**ADDENDUM #5
FORMAL BID 2022-104**

**KITSAP COUNTY PUBLIC WORKS WASTEWATER DIVISION
BANGOR-KEYPORT FORCE MAIN REPLACEMENT**

April 11, 2022

**APPENDIX E
 SUGGESTED SEQUENCING
 PLAN - PHASE 2A -
 REFERENCE ONLY**

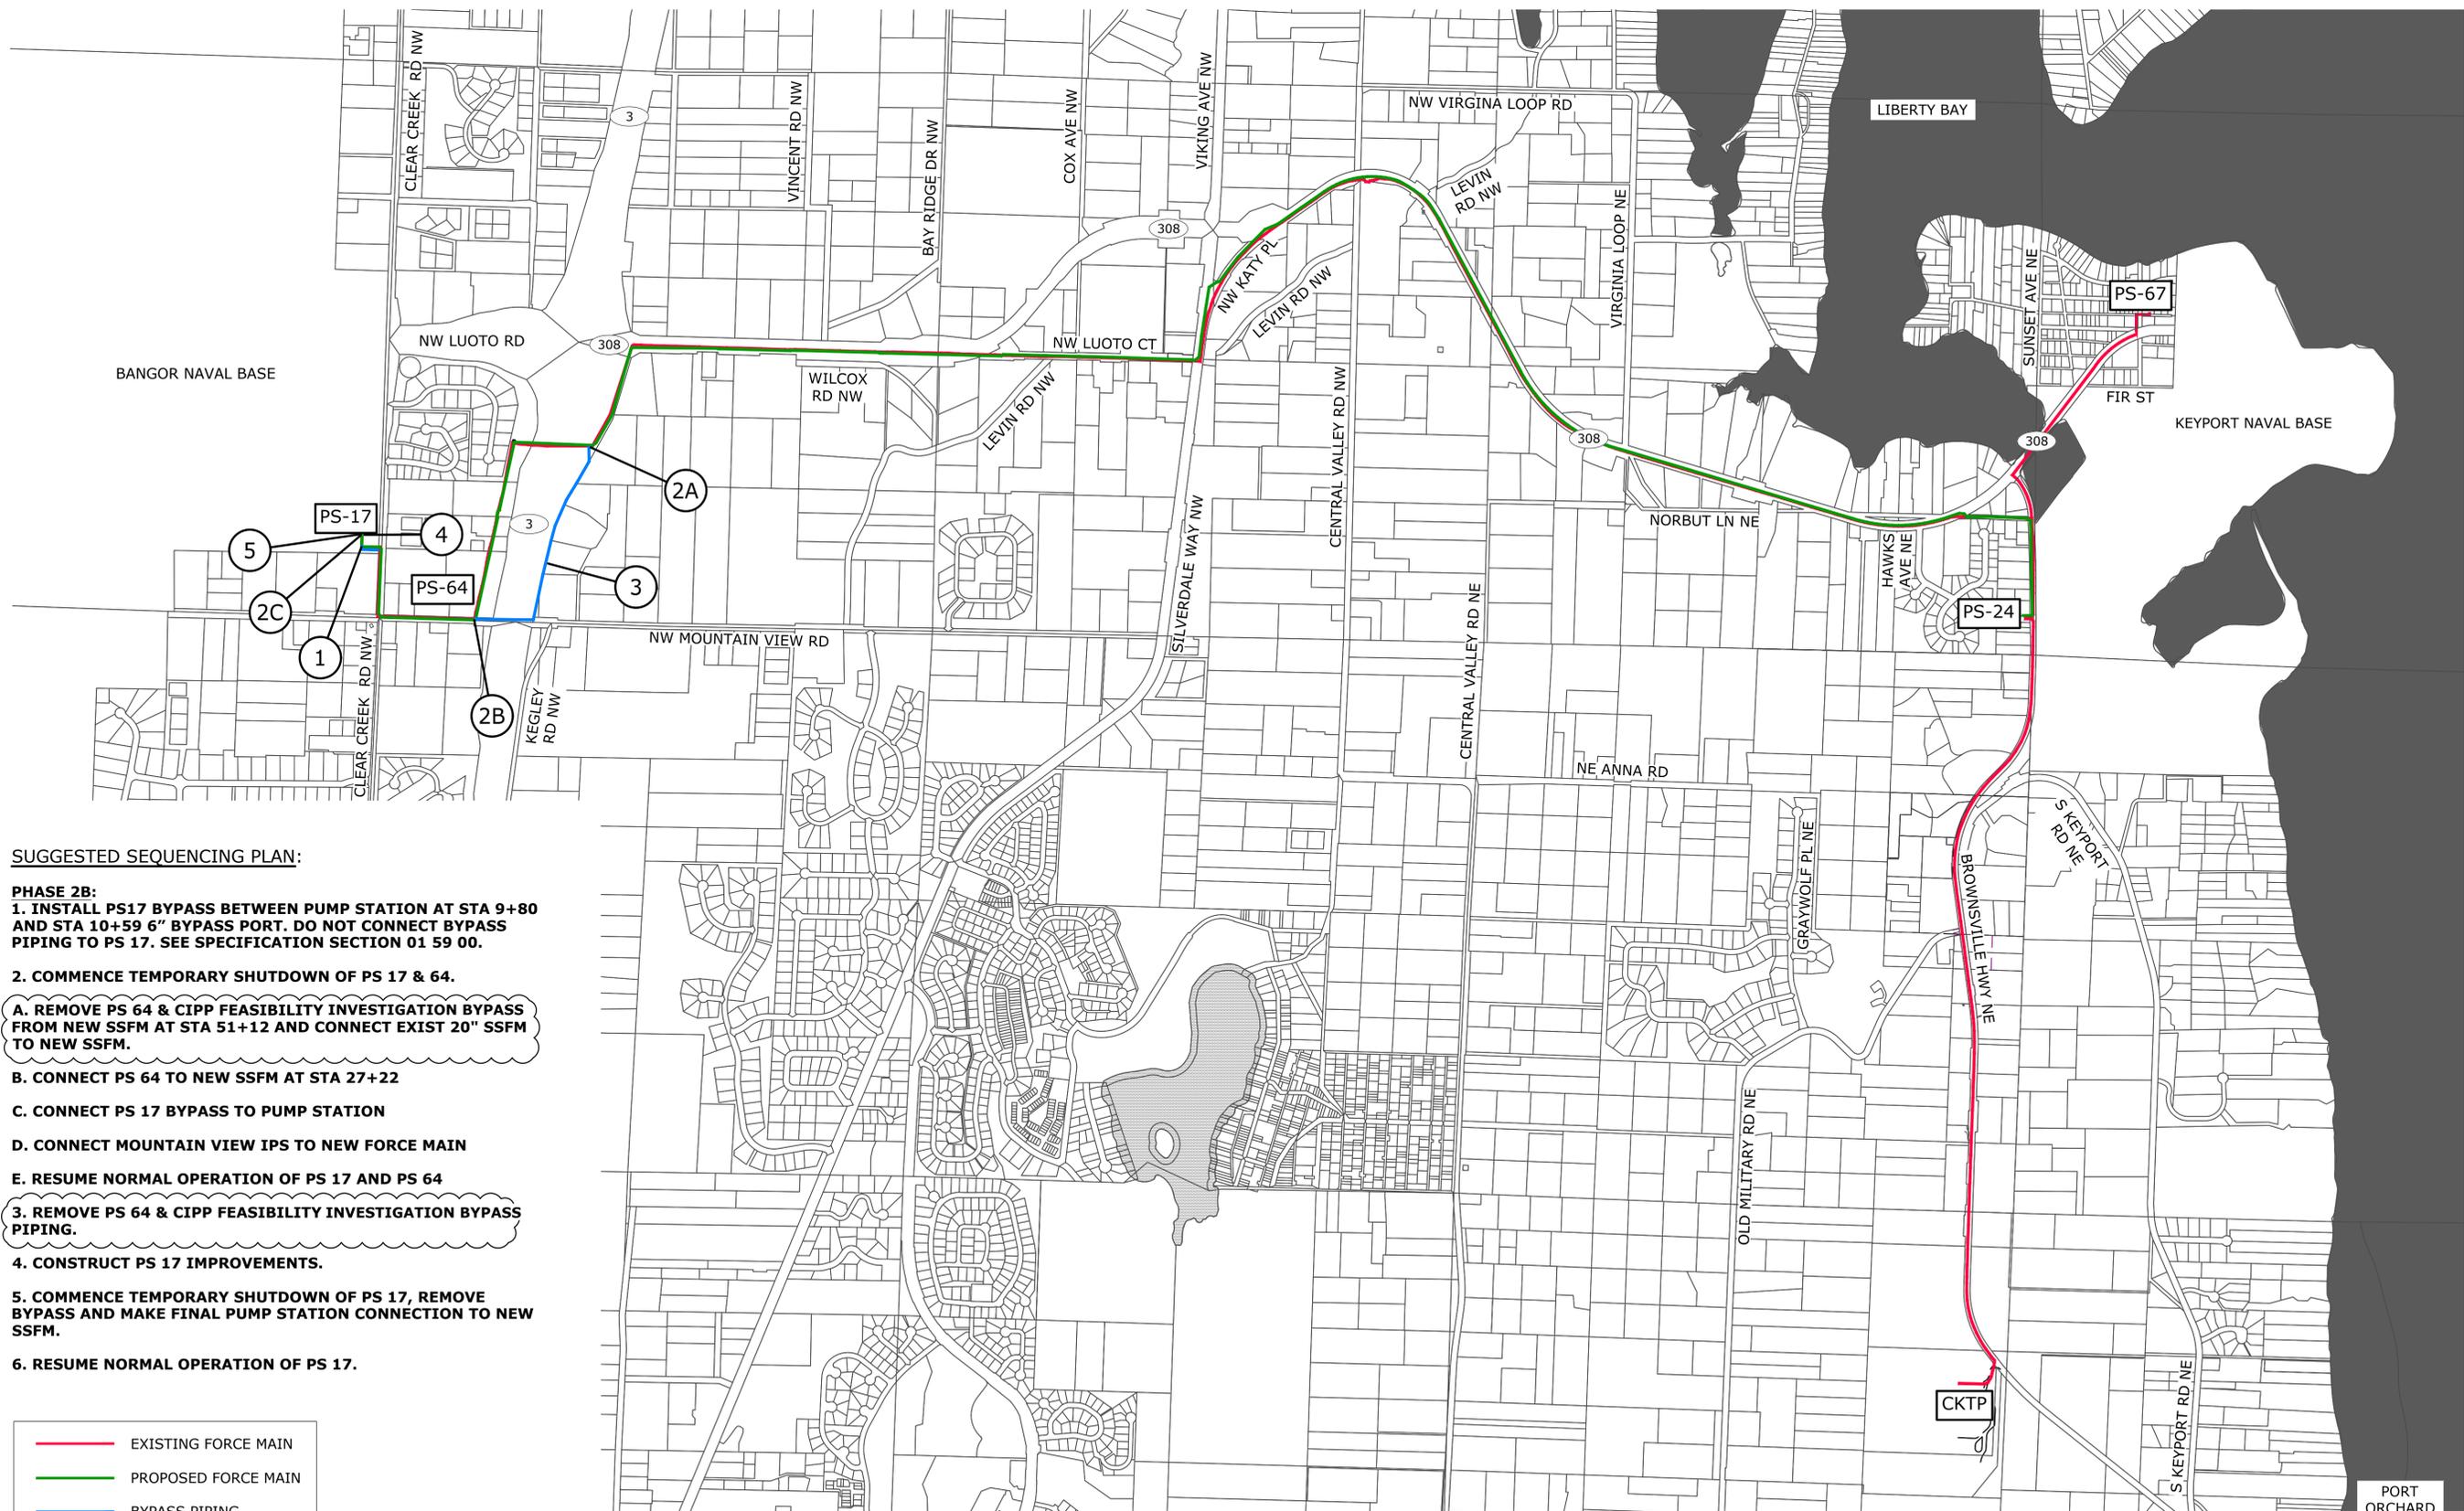
Item 8. Appendix C – Suggested Sequencing Plan REMOVE sheets 2 and 3 and REPLACE with attached sheets 2 and 3.

PHASE 2A:

- 1. INSTALL PS 64 & CIPP FEASIBILITY INVESTIGATION BYPASS BETWEEN STA 26+00 AND STA 51+12. CONNECT TO NEW SSFM AT STA 51+12, DO NOT CONNECT BYPASS PIPING TO PS 64 AND EXISTING FORCE MAIN. SEE SPECIFICATION SECTION 01 59 00.
- 2. COMMENCE TEMPORARY SHUTDOWN OF PS 17 AND 67.
 - A. CONNECT PS 64 & CIPP FEASIBILITY INVESTIGATION BYPASS PIPING TO PS 64 AND EXISTING FORCE MAIN AT STA 26+00.
 - B. CONNECT PS 67 EXISTING SSFM TO NEW FORCE MAIN AT STA 219+33, 24'LT.
 - C. RESUME NORMAL OPERATION OF PS 17, 64 & 67.
- 3. TRANSFER ARCO, SCANDIA MOBILE HOME PARK, PEARSON ELEMENTARY, AND TAGHOLM IPS'S TO NEW FORCE MAIN.
- 4. PERFORM CIPP FEASIBILITY INVESTIGATION OF SSFM FROM STA 43+56 TO STA 50+84 AND CONNECT NEW SSFM TO EXIST 20" SSFM AT STA 43+56.

*STEPS 2A AND 2B SHALL OCCUR CONSECUTIVELY, AS SEPARATE OPERATIONS.

**APPENDIX F
CIPP SUGGESTED BYPASS PLAN
- REFERENCE ONLY**

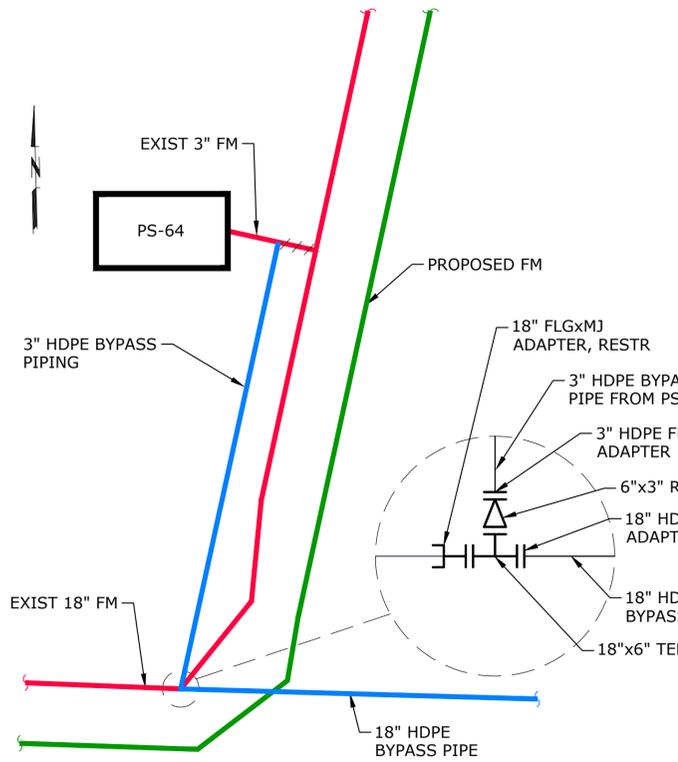
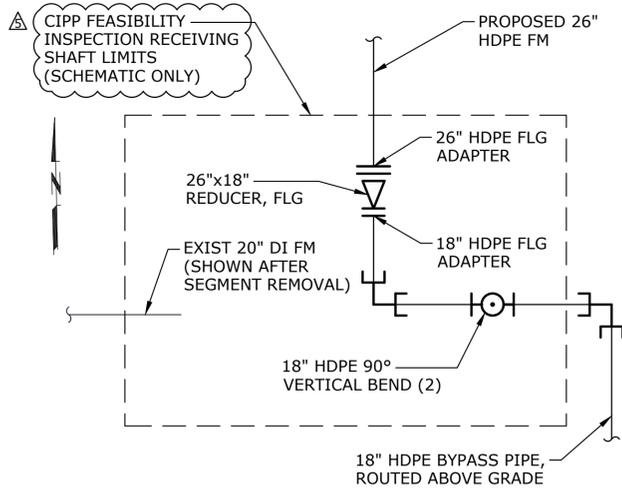
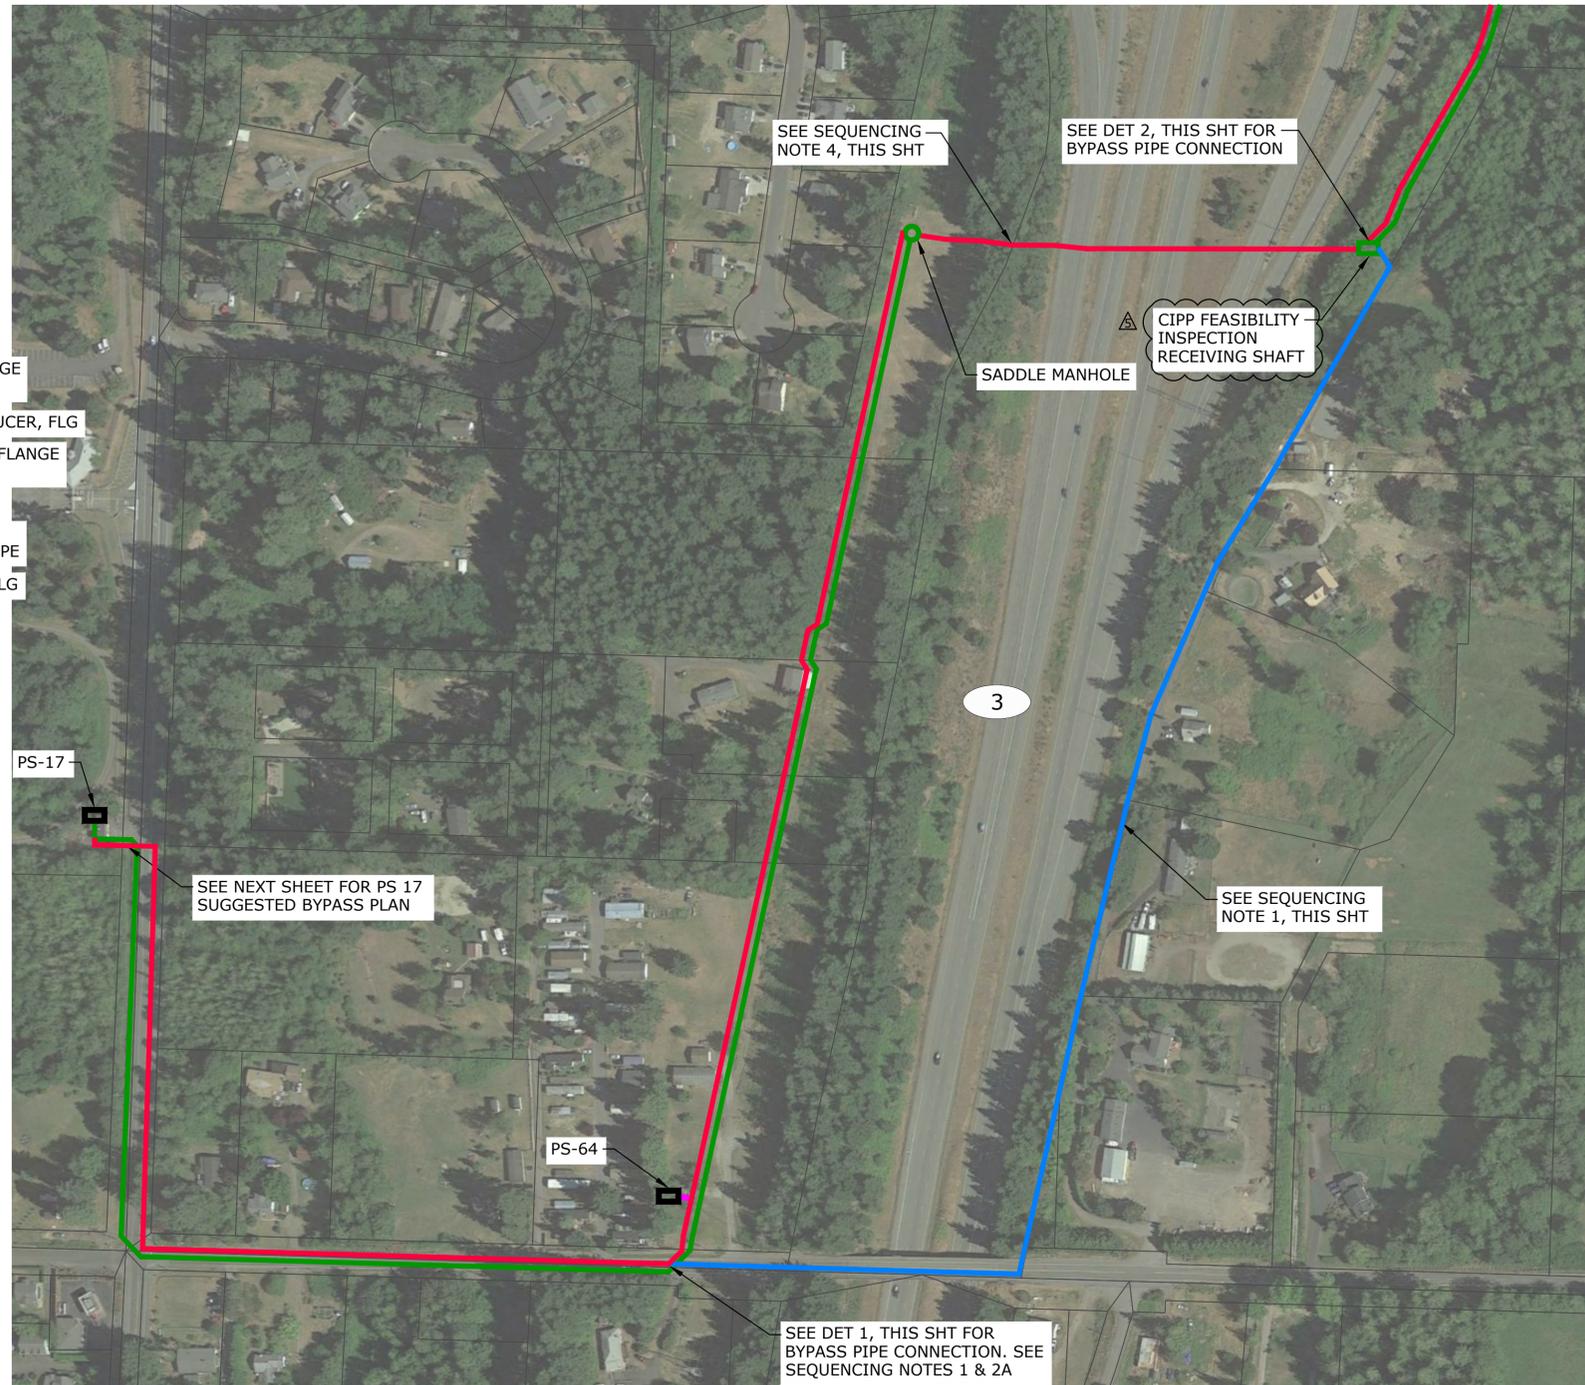
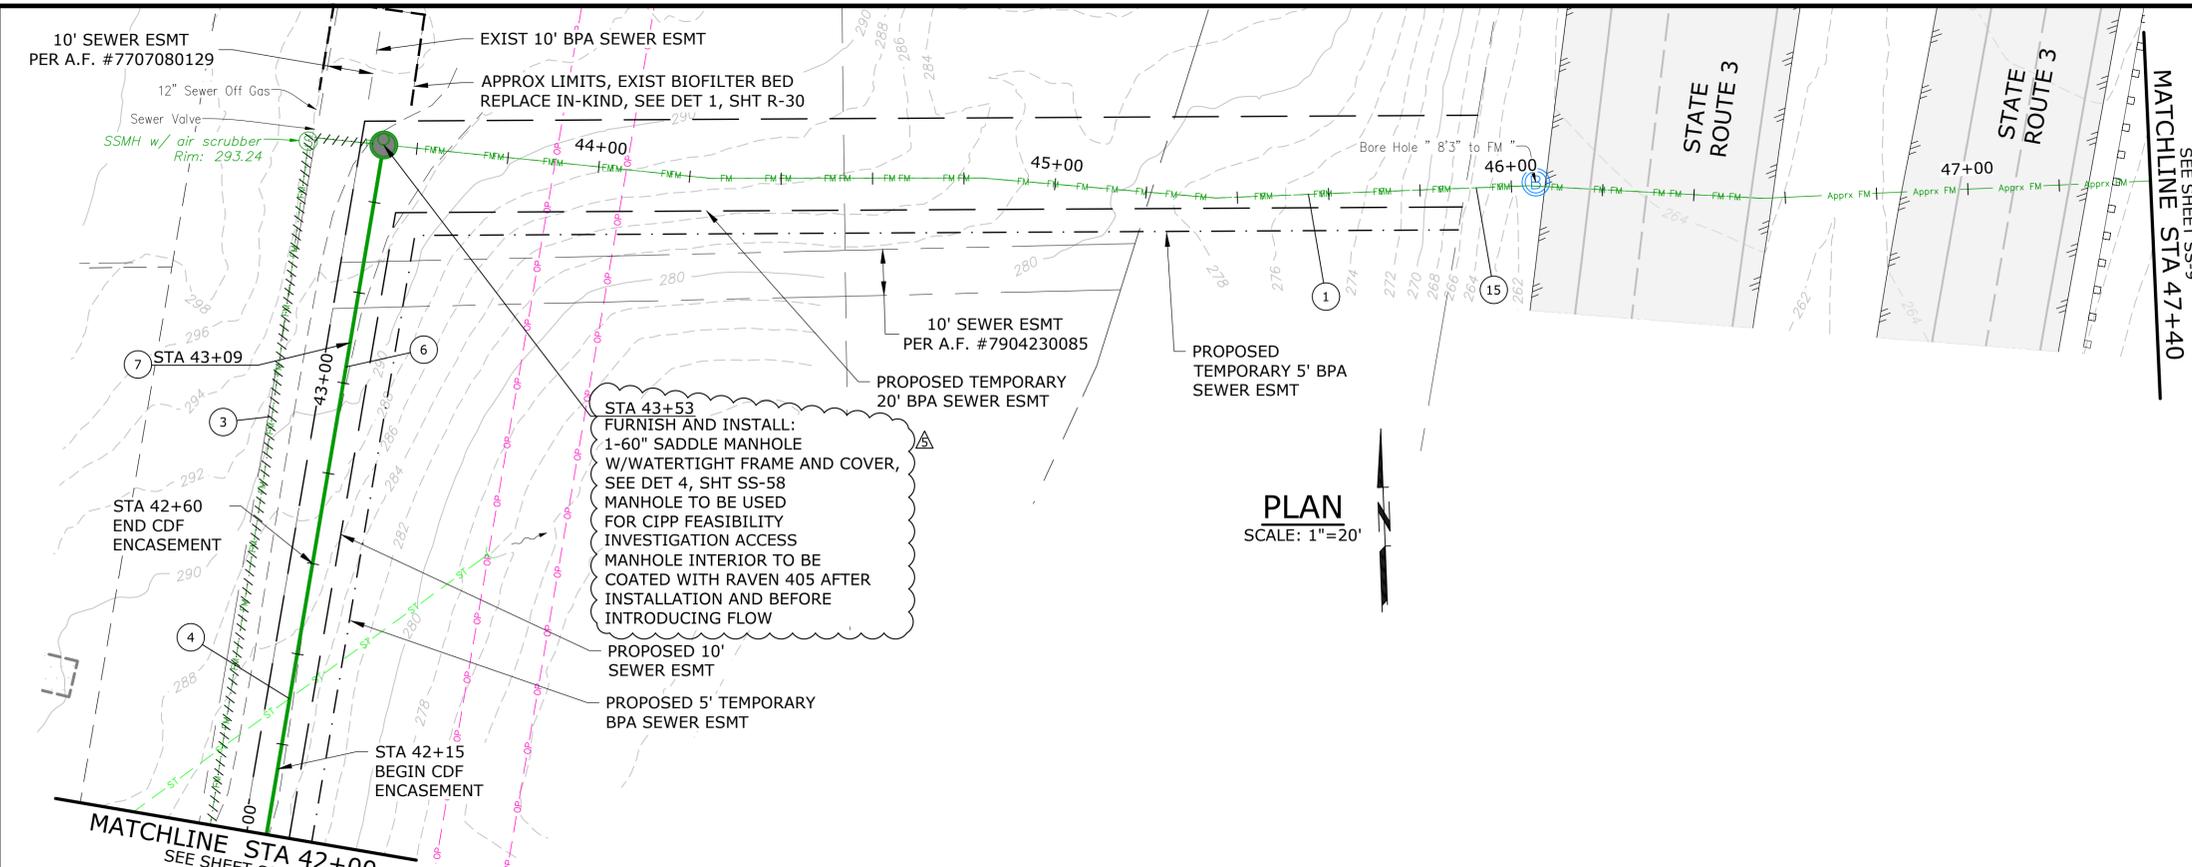
Item 9. Appendix D – Suggested Bypass Plans REMOVE sheets 1 and 2 and REPLACE with attached sheets 1 and 2.

- PHASE 2A:**
1. INSTALL PS 64 & CIPP FEASIBILITY INVESTIGATION BYPASS BETWEEN STA 26+00 AND STA 51+12. CONNECT TO NEW SSFM AT STA 51+12, DO NOT CONNECT BYPASS PIPING TO PS 64 AND EXISTING FORCE MAIN. SEE SPECIFICATION SECTION 01 59 00.
 2. COMMENCE TEMPORARY SHUTDOWN OF PS 17 AND 67.
 - A. CONNECT PS 64 & CIPP FEASIBILITY INVESTIGATION BYPASS PIPING TO PS 64 AND EXISTING FORCE MAIN AT STA 26+00.
 - B. CONNECT PS 67 EXISTING SSFM TO NEW FORCE MAIN AT STA 219+33, 24'LT.
 - C. RESUME NORMAL OPERATION OF PS 17, 64 & 67.
 3. TRANSFER ARCO, SCANDIA MOBILE HOME PARK, PEARSON ELEMENTARY, AND TAGHOLM IPS'S TO NEW FORCE MAIN.
 4. PERFORM CIPP FEASIBILITY INVESTIGATION OF SSFM FROM STA 43+56 TO STA 50+84 AND CONNECT NEW SSFM TO EXIST 20" SSFM AT STA 43+56.
- *STEPS 2A AND 2B SHALL OCCUR CONSECUTIVELY, AS SEPARATE OPERATIONS.
